645-017-11

ADDENDUM NO. 2

Wayne State College
Carhart Building Phase III
Wayne, NE
TCEP No.: 645-017-11

Addendum #2
 Supplemental Drawing: SDM-004
 Revision of Sheet: M1.1
 Date: April 10, 2012

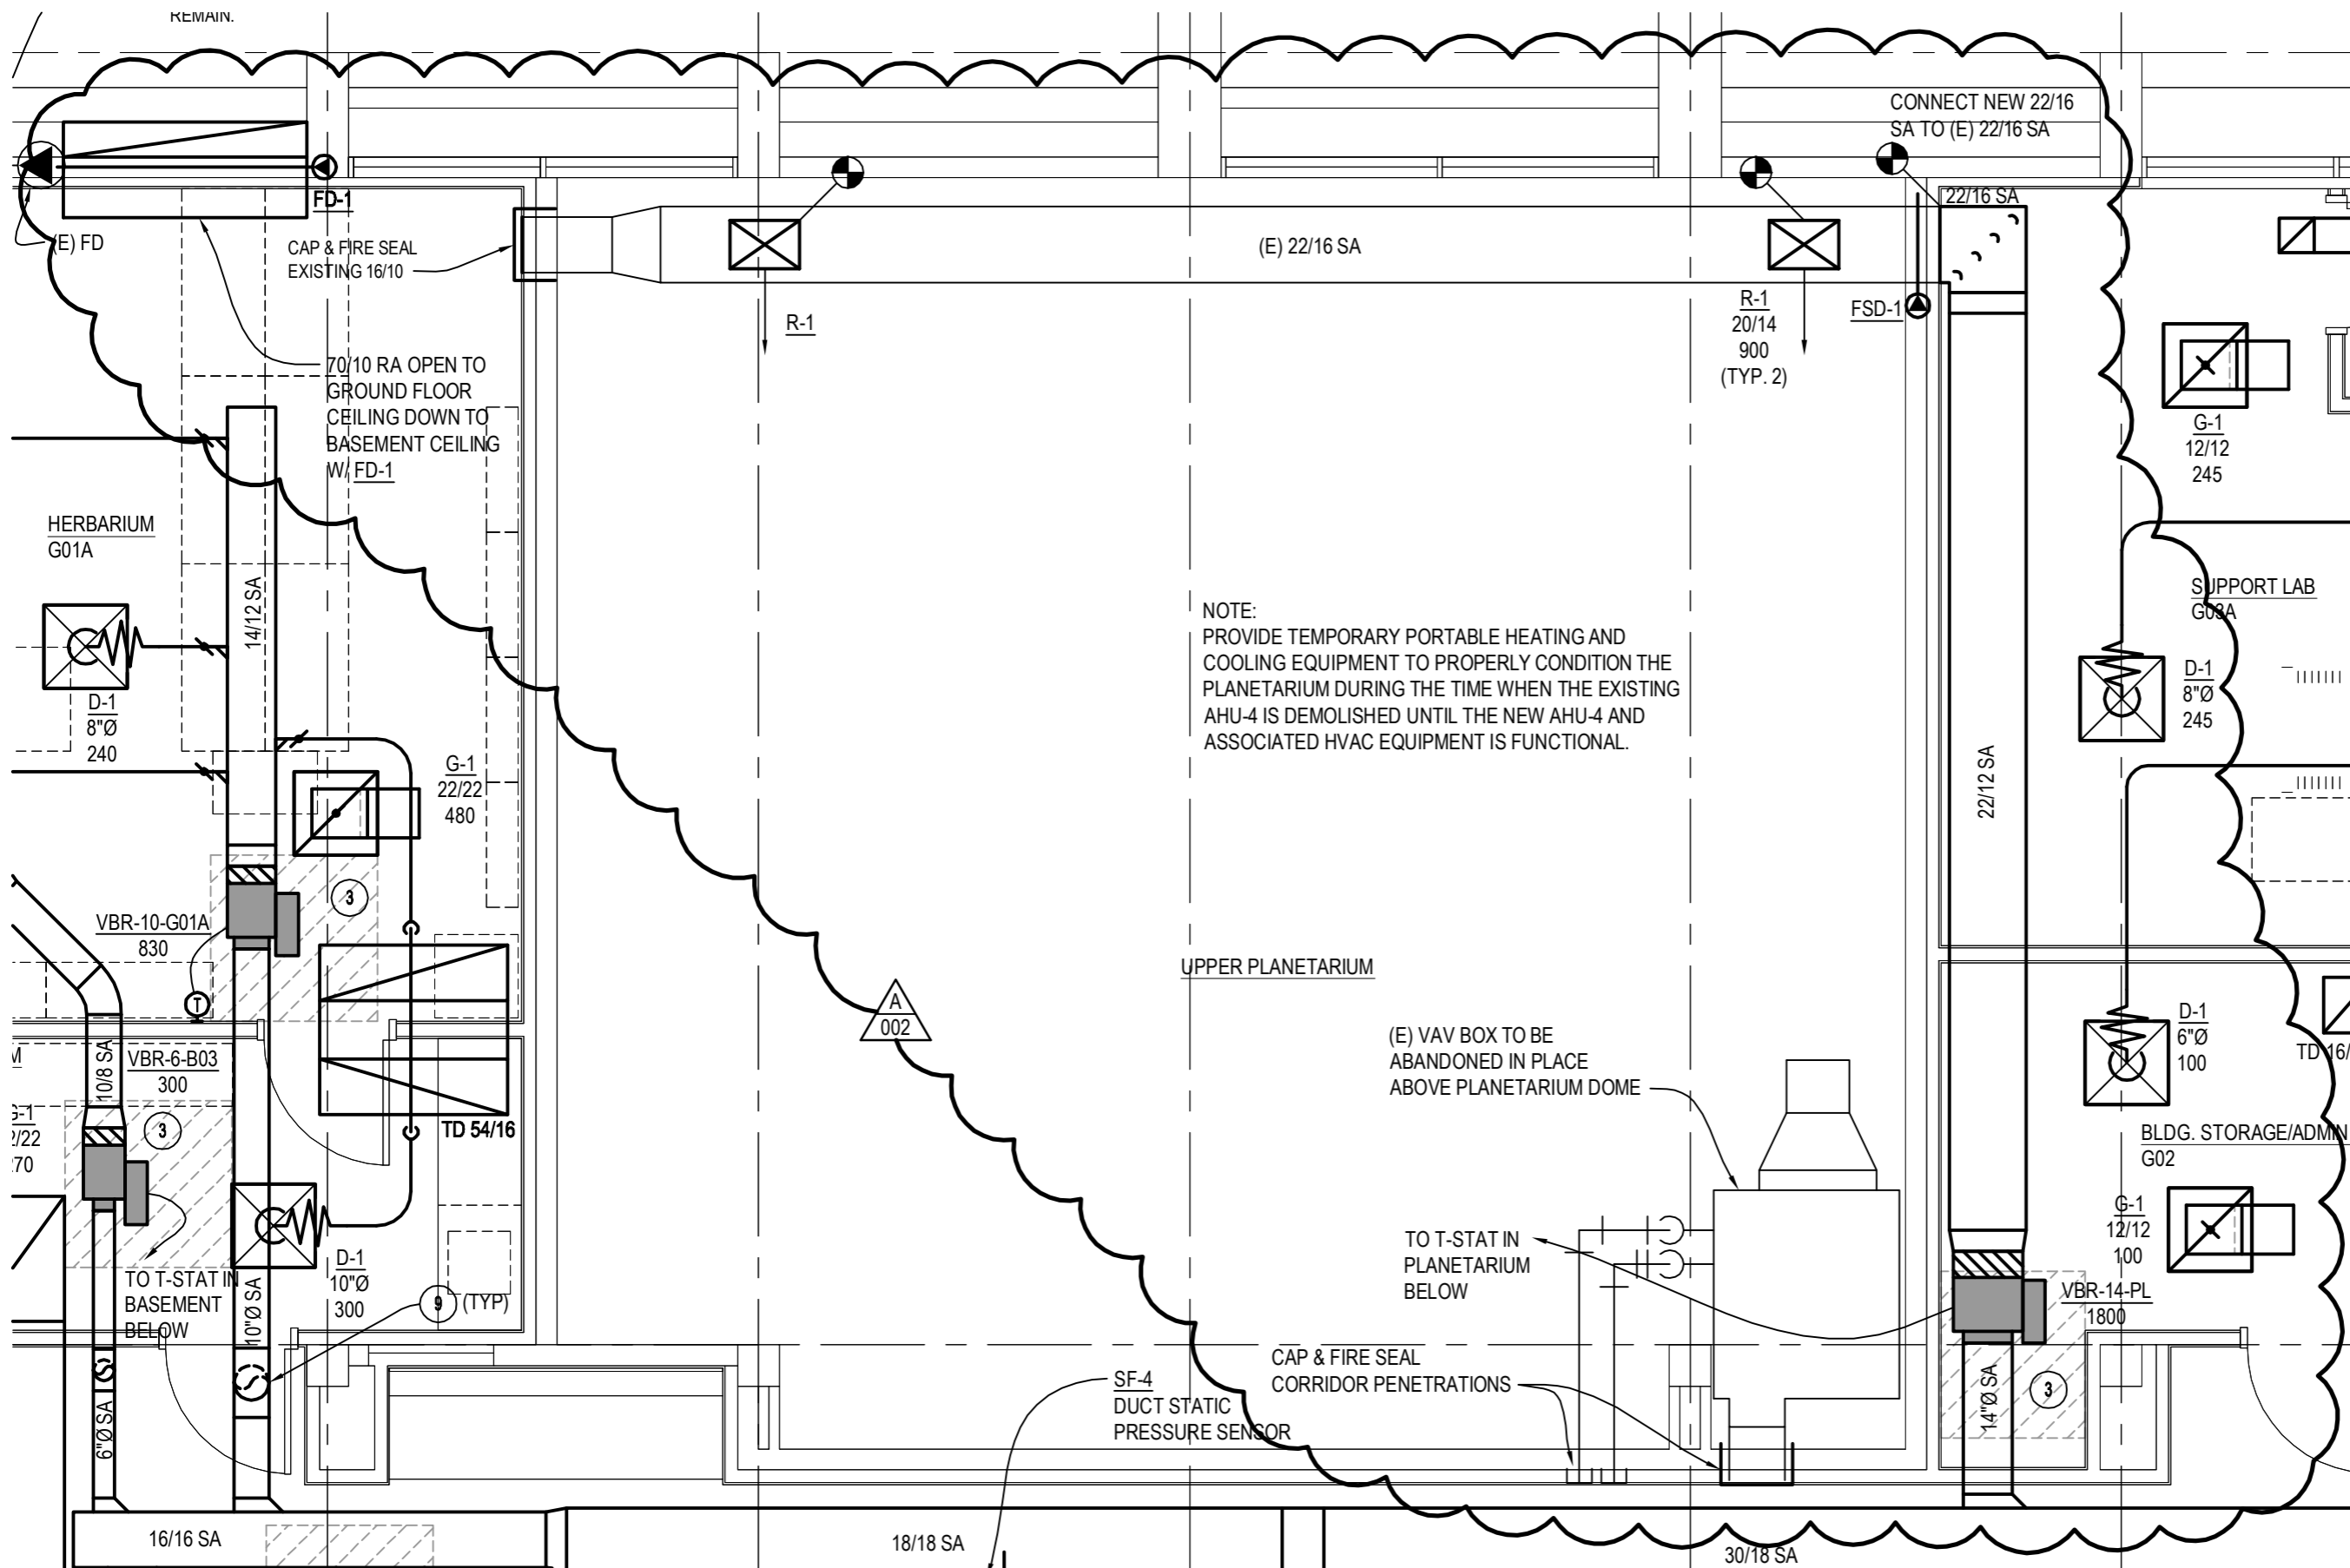
Provide 24/24 TD or equivalent from Planetarium Lobby B03 ceiling plenum to Planetarium ceiling plenum above Storage B01A ceiling in South East corner of Planetarium Basement Ceiling with FSD-1 as shown on SDM-004.

Move VBR-14-PL into G02 to provide improved access as shown on SDM-004 and route associated 1 ¼" HWS/HWR branch piping to revised location.

Addendum #2
Supplemental Drawing: SDM-005
Revision of Sheet: M1.2
Date: April 10, 2012

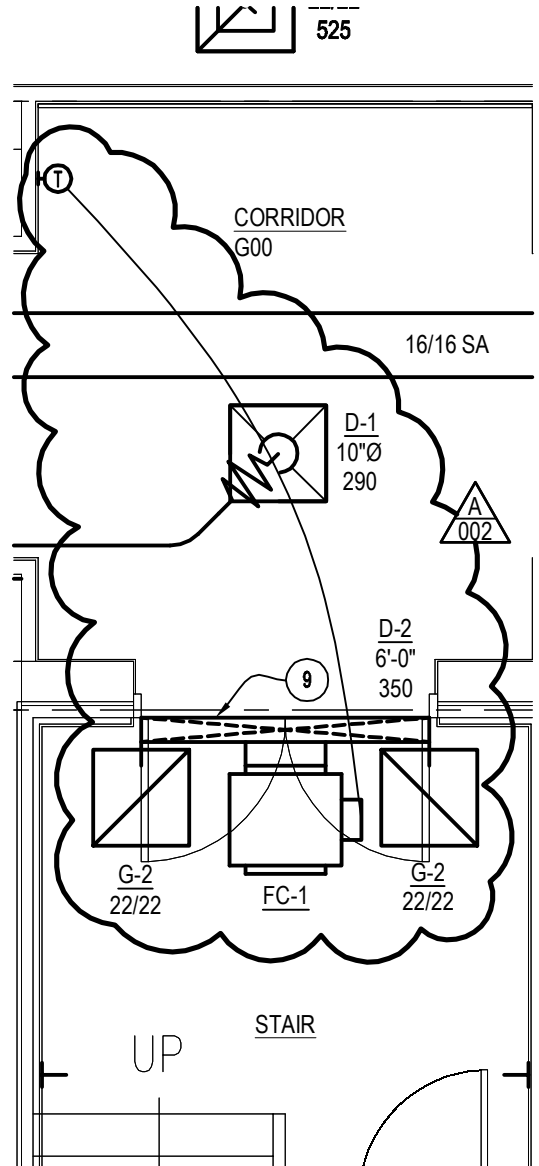
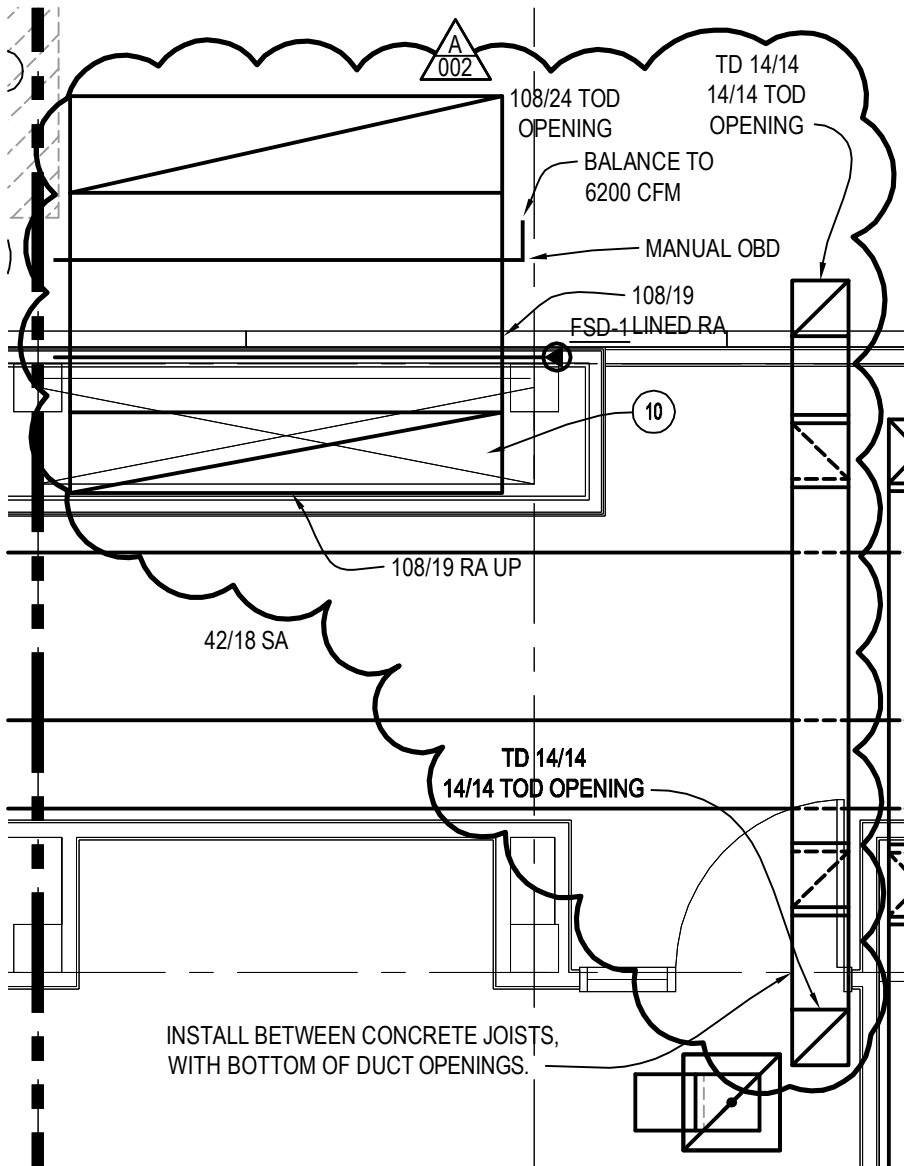
Remove 40/16 RA TD from Ground ceiling into Upper Planetarium. Modify SA and RA ductwork serving the Planetarium as shown on SDM-005, including relocating VBR-14-PL and associated ductwork into G02. Reroute SA ductwork from VBR-14PL through Storage G02 and Support Lab G03A and connect new SA to the existing 22/16 duct above Planetarium to serve as the SA duct with (2) 20/14 R-1's installed on the bottom of the existing duct as shown on SDM-005. Adjust R-1 double deflection air foil blades to spread the supply air discharge throughout the Planetarium above the dome.

Provide a new 70/10 RA in existing exterior chase routed from Ground ceiling down to Basement ceiling plenum with fire damper at entrance into chase to eliminate new wall openings for ductwork above Planetarium dome as shown on SDM-005.

Addendum #2
Supplemental Drawing: SDM-006
Revision of Sheet: M1.3
Date: April 10, 2012

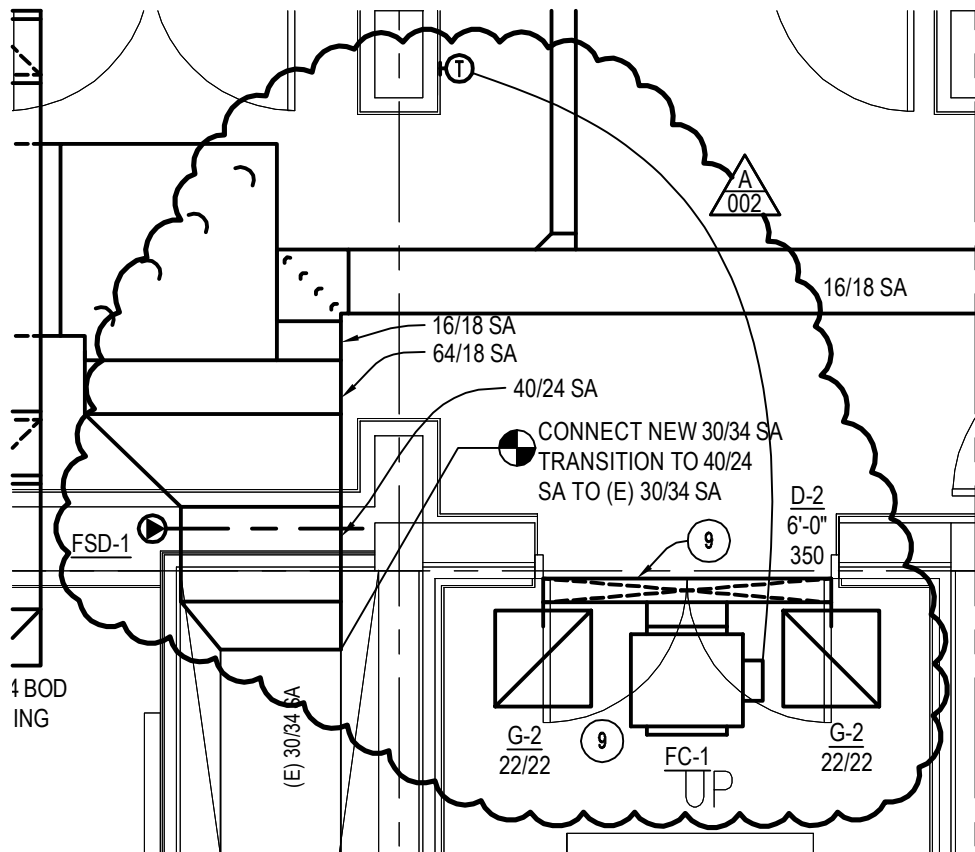
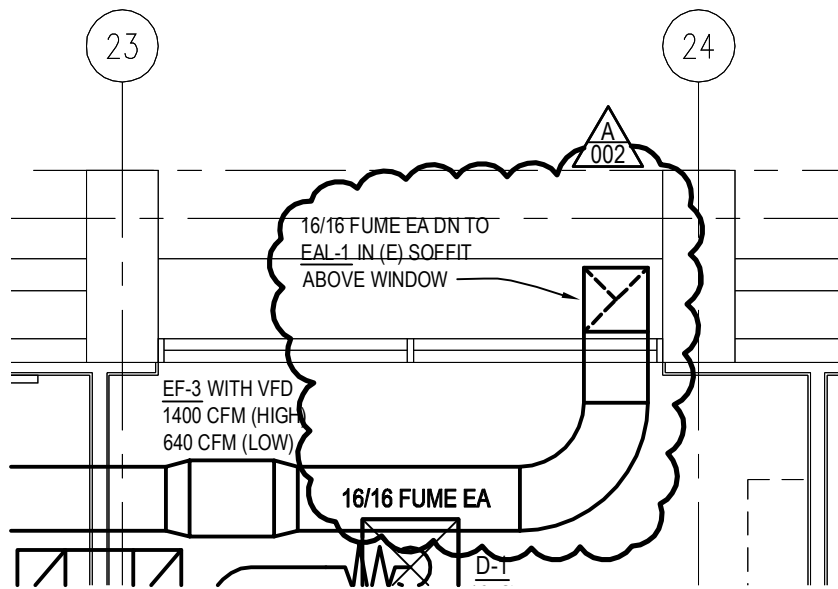
Change RA duct from chase into the G03 ceiling plenum on the plans and noted in Plan note #10 from 108/16 to 108/19 with FSD-1 as shown on SDM-006.

Provide FC-1 t-stat on north side of column 23-X in Corridor G090 and shift (2) FC-1 access RA grilles closer together as shown on SDM-006. FC-1 and associated fan, modulating hot water coil control valve and t-stat to be to be interfaced and controlled by the EMCS to operate as necessary to satisfy the corresponding corridor t-stat. EMCS to also provide individual adjustment and control of occupied and unoccupied operation at the EMCS operator work station.

Addendum #2
Supplemental Drawing: SDM-007
Revision of Sheet: M1.5
Date: April 10, 2012

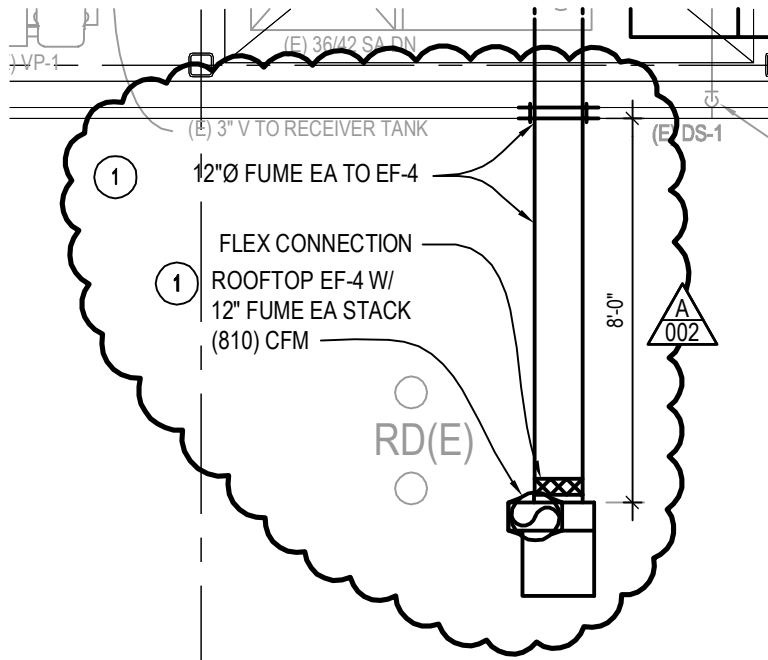
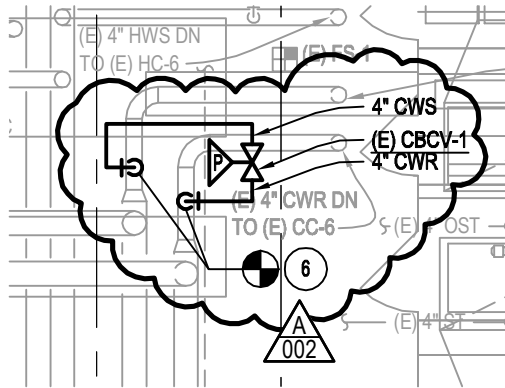
Provide 16/16 EA from EF-3 to EAL-1 installed in exterior soffit as shown on SDM-007. EA duct downstream of EF-3 to be fume exhaust type ductwork constructed same as other fume exhaust air ductwork with welded stainless steel seams and joints and no flexible duct connections.

Provide FC-1 t-stat on north side of column 23-X in Corridor G090 and shift (2) FC-1 access RA grilles closer together as shown on SDM-007. FC-1 and associated fan, modulating hot water coil control valve and t-stat to be interfaced and controlled by the EMCS to operate as necessary to satisfy the corresponding corridor t-stat. EMCS to also provide individual adjustment and control of occupied and unoccupied operation at the EMCS operator work station.

Change duct through rated corridor wall and FSD-1 from 90/24SA to 40/24 SA as shown on SDM-007.

Addendum #2
Supplemental Drawing: SDM-008
Revision of Sheet: M1.6
Date: April 10, 2012

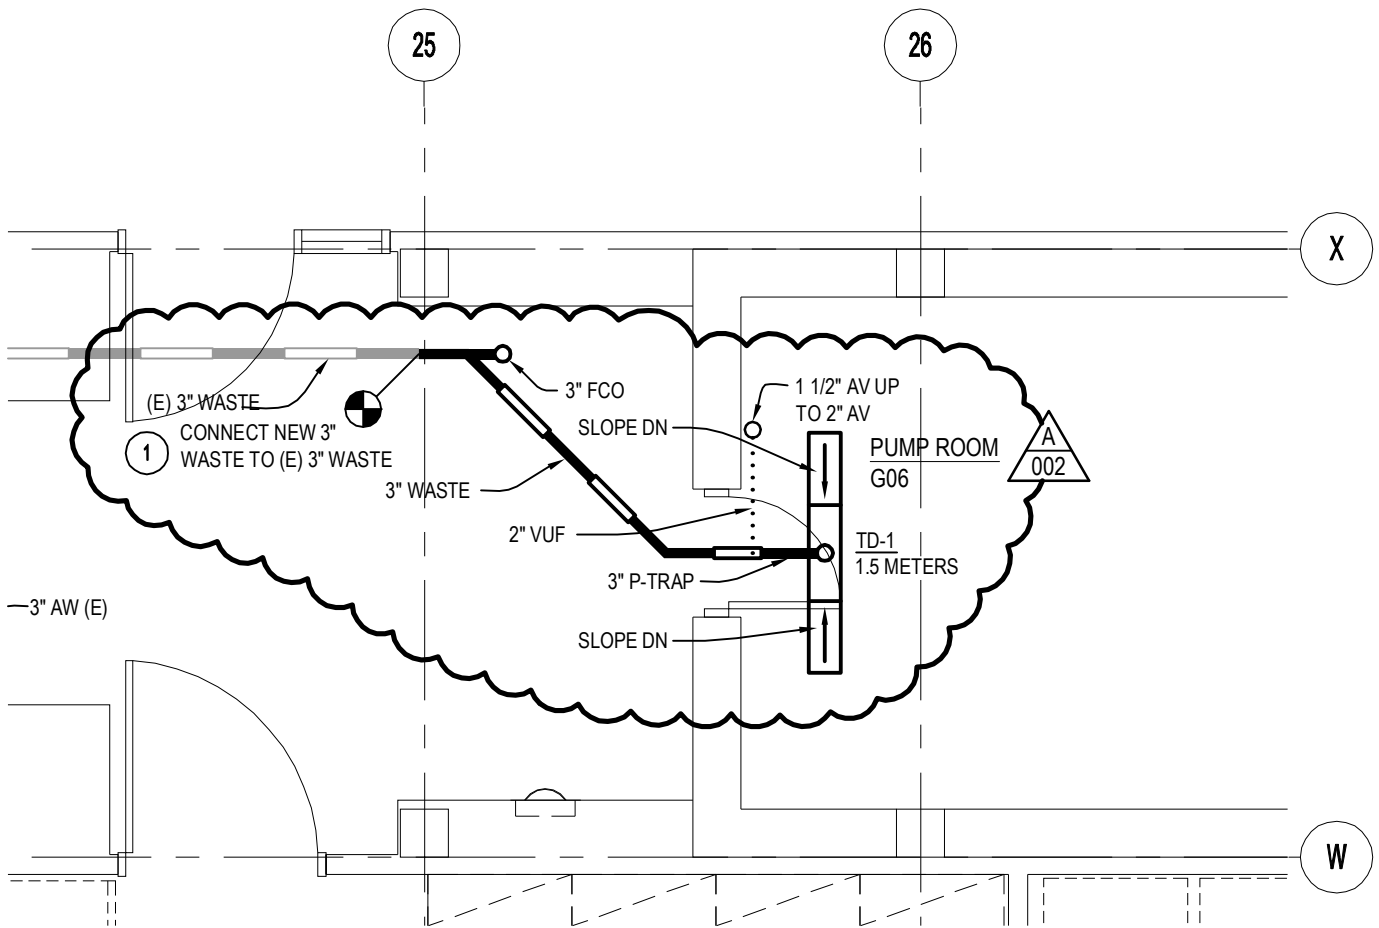
Change symbol on the CBCV-1 to the Delta P pressure independent type to (E) CBCV-1 as shown on SDM-008. Install the owner furnished Delta P model EDP-235-5, Serial # 4-60598 that served the previous AHU-3 (formerly tagged CCV-3) in lieu of providing the new scheduled CBCV-1. This existing owner furnished 4" control valve to be installed in the 4" chilled water bypass to maintain the minimum chilled water flow rate to prevent the chilled water pumps from dead heading and controlled as specified for CBCV-1.

Refer to Plan Note #2, change the word following 36/20 RA from "on equipment" to "or equivalent" as shown on SDM-008.

Addendum #2
Supplemental Drawing: SDM-009
Revision of Sheet: M2.2
Date: April 10, 2012

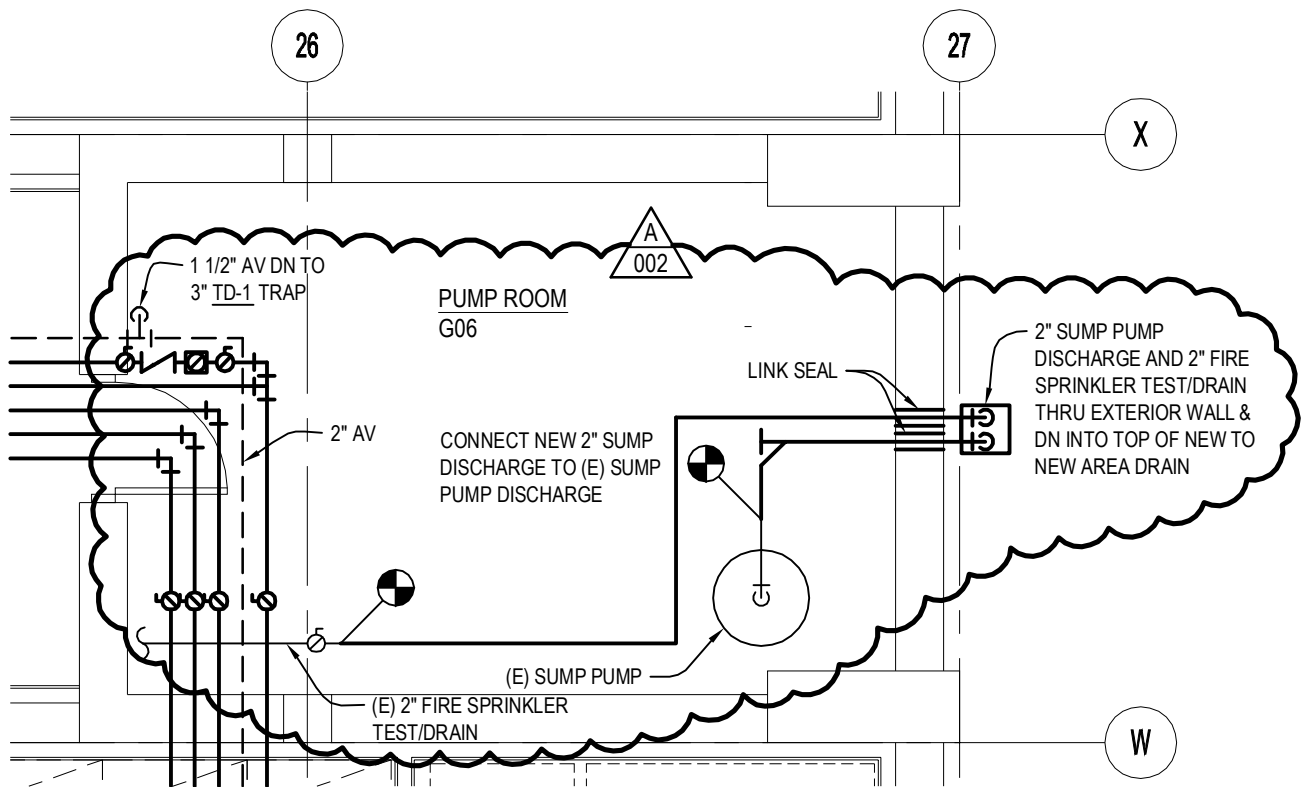
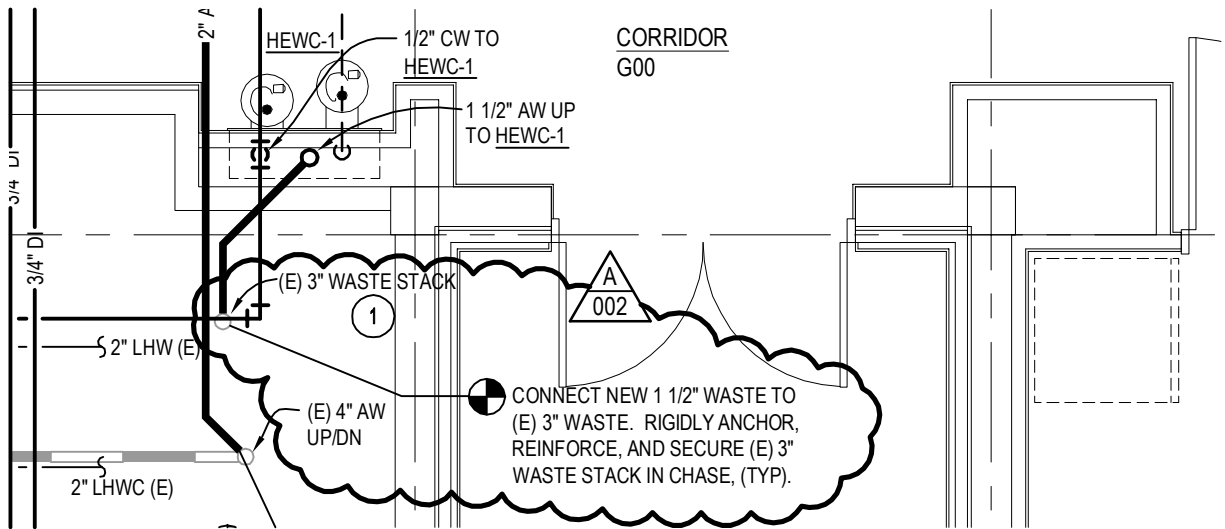
Add a fire Pump Room G06 trench drain (TD-1) between the existing housekeeping pads in front of the man door at the approximate location shown. Route trapped 3" waste from center low point bottom of sloped TD-1 to existing 3" waste (field verify exact location) with 2" VUF to 1 1/2" AV up exposed to new 2" AV. Also provide a new 3" floor clean out at the end of the existing 3" waste connection to existing as shown on SDM-009 and SDM-010.
